Our Ref: BNE220533

Property Location:	417 Sandgate Road, Albion 4010
Application:	A006321182 – Original approval
Property Description:	Lot 1 on RP127006
Development:	S81 Minor Change Request
Client:	Good Karma (Salisbury) Pty Ltd

This supplementary further information relates to a minor change made under Section 78 of the *Planning Act 2016* ("PA") and seeks to change development approval A006321182.

Figure 2 – Energex Sketch Plan

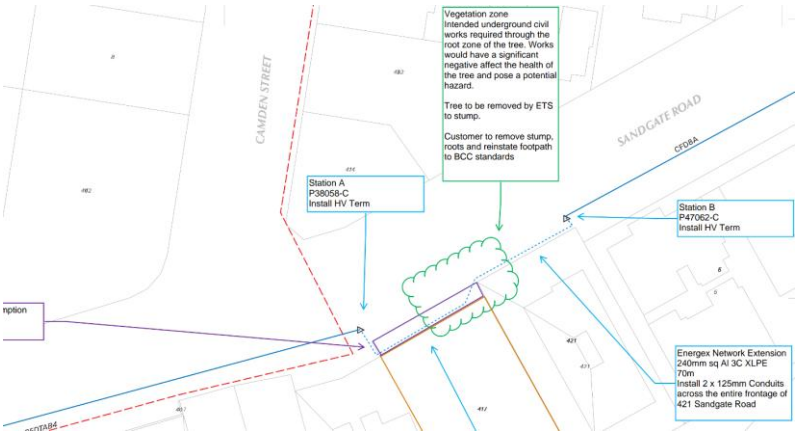
As part of electrical works, the site is not proposed to be serviced by an overhead connection with the proposal to include an underground connection to the site. In addition to this, Energex will be providing an underground conduit along the site's frontage (within the dedication area) and the frontage of 421 Sandgate Road to provide a connection between Poles P38058-C and P47062-C. This realignment allows for the ultimate realignment of road along the site frontage. A plan which has been provided by Energex (refer **Attachment B**) that identifies that 2 x 125mm conduits will be installed. Energex notes on

their plan that the tree and stump is to be removed due to the proposed works required within the root zone of the tree, refer **Figure 2** below.

Based on Energex's requirements, it is proposed that they require to the street tree be removed.

Figure 3 – Ultimate Road Alignment Plan show ultimate kerb and verge profile

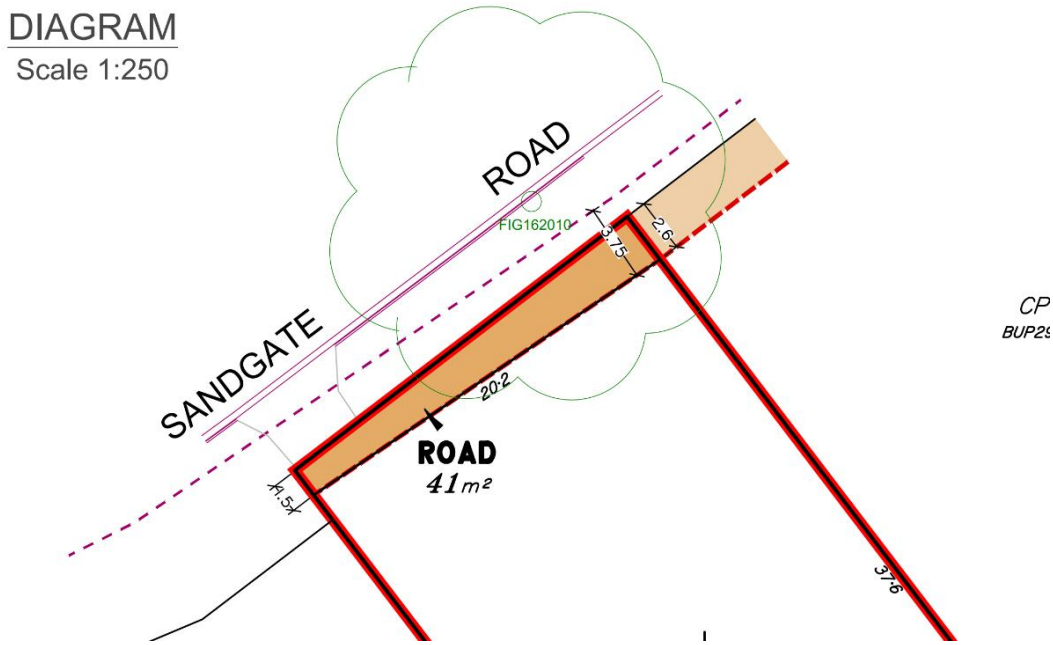
Sandgate Road is identified within the Streetscape hierarchy overlay as being a Subtropical Boulevard out of centre 3.75m/4.25m road. This requires a verge of either 3.75m for existing roads or 4.25m for new roads. It is clear, as identified on **Attachment C** and **Figure 3** below that in either circumstance the tree would be required to be removed by Council to facilitate the ultimate road and kerb alignment.

Notwithstanding that Energex requires the tree removal to facilitate their electrical works within the verge, the tree would ultimately need to be removed to allow Council's ultimate road works along Sangate Road.
